Ref: DECISION NOTICE 136879/FO/2023

RE: DECISION NOTICE 136879/FO/2023 FRM OUTSTANDING COMMENTS

The purpose of this letter is to provide a summary of the airports current surface water network arrangement in respect of the Bollin catchment and confirms details of the Bollin Outfall arrangement including capacities in respect of the proposed Box 4 development which is proposed to connect to the airports privately owned drainage network upstream of the United Utilities outfall sewer. Manchester City Councils Flood Risk Management team are seeking clarity on the acceptance of flows from the MAG network into the Bollin Outfall Sewer.

EPR/CB3299EN Permit Variation Site Plan
Surface Water Drainage System Catchment Areas, Main Network and Sample Points

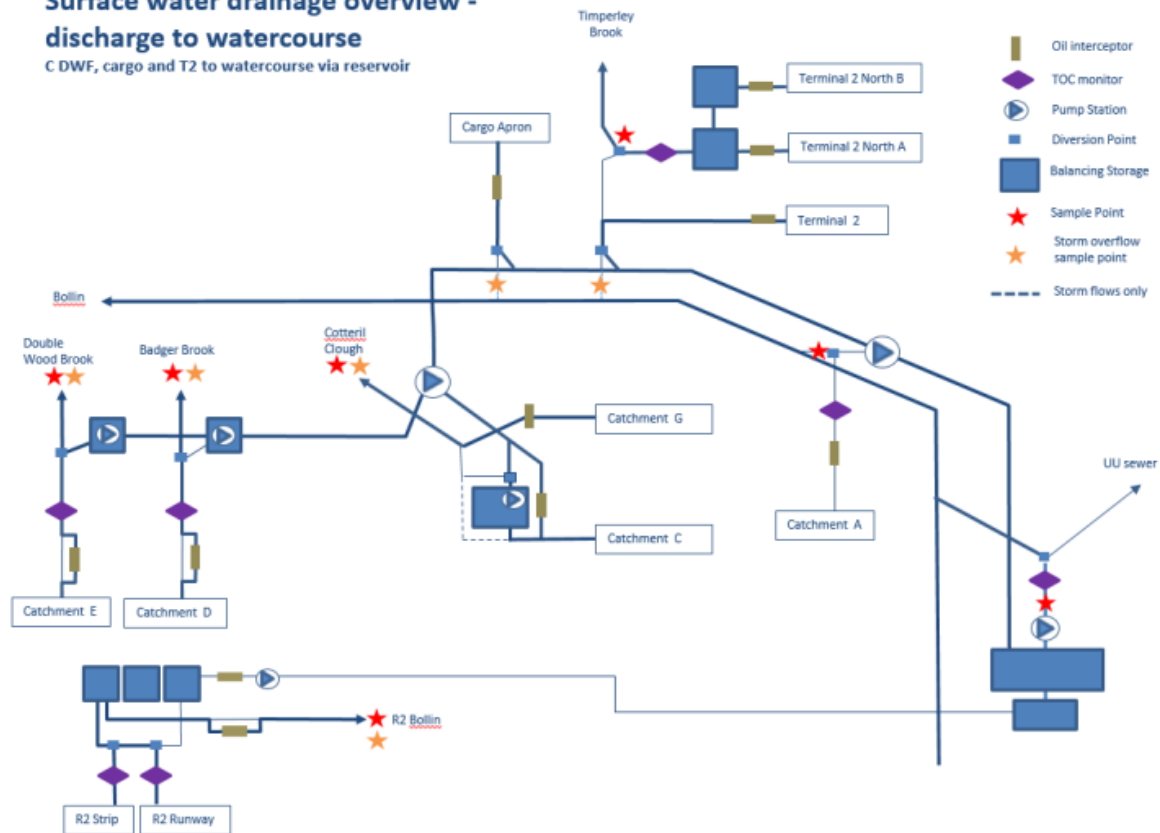
Details of surface water attenuation that offers a reduction in surface water runoff rate in line with the Manchester Trafford and Salford Strategic Flood Risk Assessment, i.e. at least a 50% reduction in runoff rate compared to the existing rates with the aim of reducing to the Greenfield runoff rates, as the site is located within Conurbation Core Critical Drainage Area;	N	N	The 'Bollin Outfall Tunnel' is presumed to be the public surface water sewer NW of the site (approx. 1910 dia. in public sewer records). Please confirm if the Bollin Outfall Tunnel is in the public sewer network. Where surface water is ultimately discharging to the public sewer, agreement in principle from United Utilities is required that there is adequate spare capacity in the existing system taking future development requirements into account. An email of acceptance of proposed flows will suffice.
---	---	---	---

The arrangement of the Bollin outfall is shown in the figures below:

Clean runoff from is allowed to discharge into the MA's surface water drainage system via Outlet A and ultimately discharged into the River Bollin at the Castle Mill Bollin Outfall.

T2 and Cargo catchments as outlined in the management plan are in permanent containment mode and there is no plan to change this in the future due to below ground assets not being accessible. This means no clean flows will be directed to watercourse (Bollin) from the mentioned above catchments as originally anticipated by design.

Even with the full catchment contribution there would be deemed significant capacity in the Bollin Outfall Sewer however given that pass forward flows from a significant area of the catchment are no longer contributing it is deemed that there is greater headroom in the outfall tunnel than previously assumed.
